Minutes
Cascade Charter Township
Planning Commission
Monday, November 13, 2023
7:00 pm
2870 Jacksmith Ave SE

STAFF REPORT: Case # 22-3798
REPORT DATE: October 27, 2023
PREPARED FOR: Cascade Charter Township Planning Commission
MEETING DATE: November 13, 2023
PREPARED BY: Madison Smith-Jacoby

STAFF REPORT: Case # 23-3795
REPORT DATE: November 4, 2023
PREPARED FOR: Cascade Charter Township Planning Commission
MEETING DATE: December 4, 2023
PREPARED BY: Madison Smith-Jacoby, Zoning Administrator

STAFF REPORT: Case # 23-3800
REPORT DATE: November 17, 2023
PREPARED FOR: Cascade Charter Township Planning Commission
MEETING DATE: December 4, 2023
PREPARED BY: Madison Smith-Jacoby

BASIN OUTLET STRUCTURE (OS-7)
NOT TO SCALE

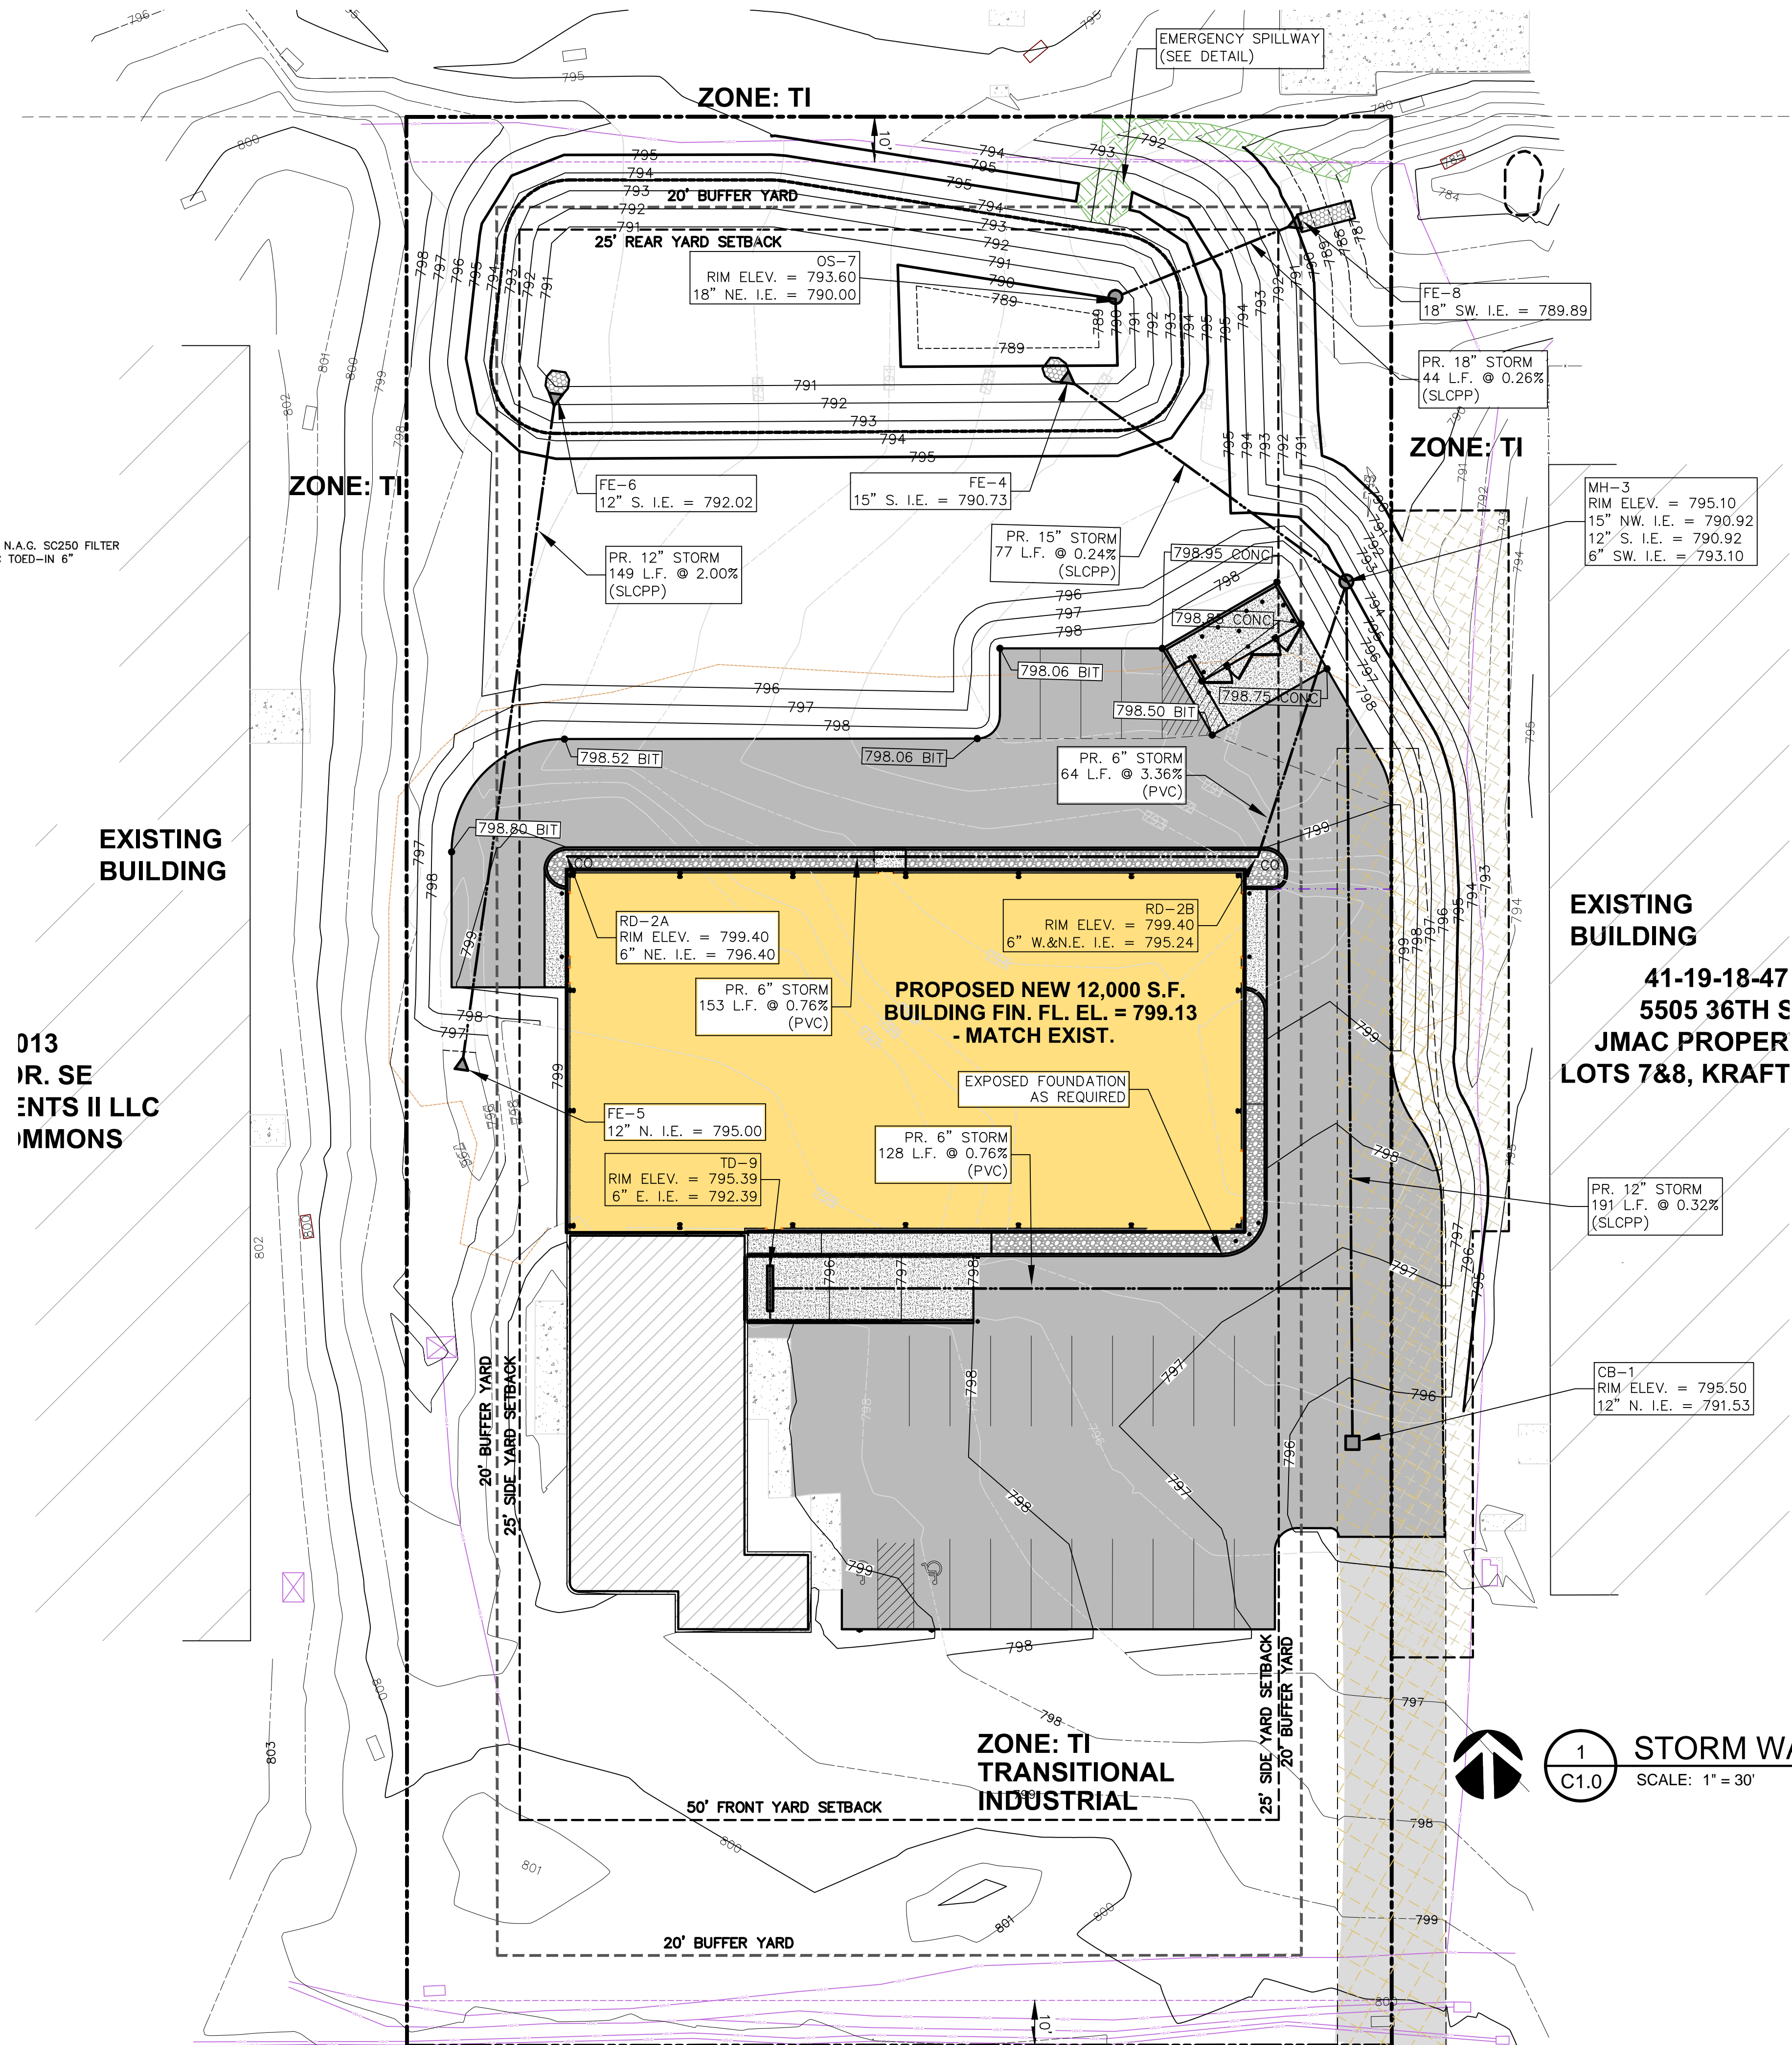
The proposed detention basin is located in the rear of the parcel. Two inlets sized 12- to 15-inch diameter drain the impervious area to the basin. Inlets include energy dissipation via riprap protection. Outlet design includes primary and emergency overflows. An 18-inch diameter outlet drains the basin to a low lying area to the east. Plans include a section detail for the outlet

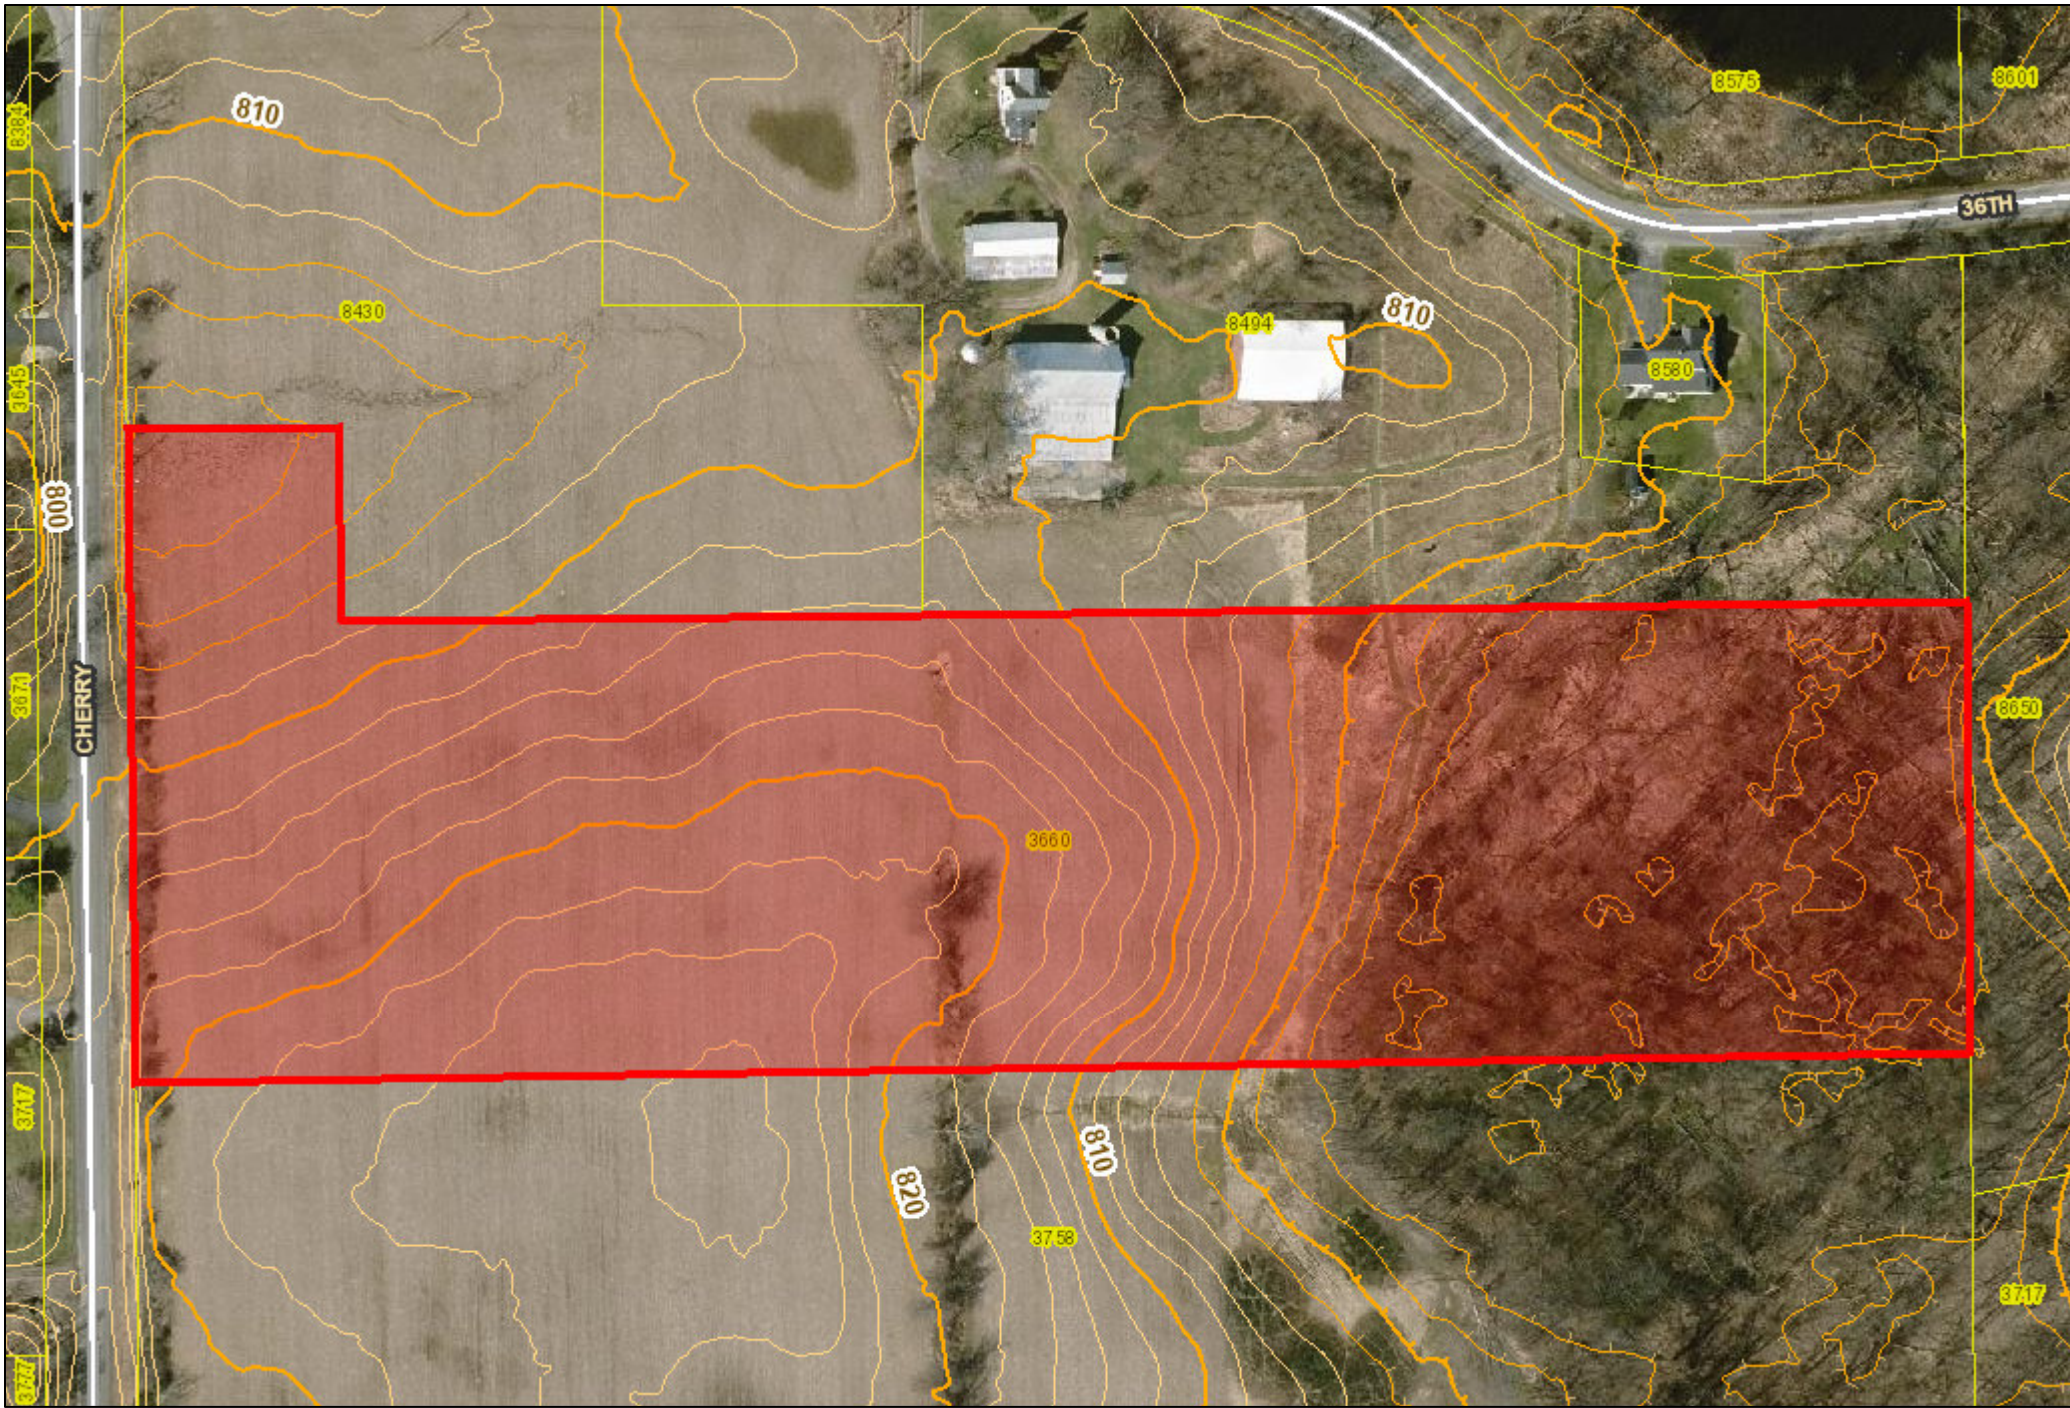
- E. The parcel does not appear to have steep hills but the east end of the property gradually descends into what appears to be lower wetlands. A topographical map is included in this packet. Refer to the applicant for drainage, berm, and stormwater diversion plans.

- G. The site plan indicates that a driveway to the barn will be added as an extension of off the main drive to the home. Please refer to the applicant about material used for the drive as it is not indicated in the plan.

1. The building not be used to run a business.
2. The building not be used for dwelling space.
3. Outdoor lighting adheres to the Cascade Township ordinance standards.
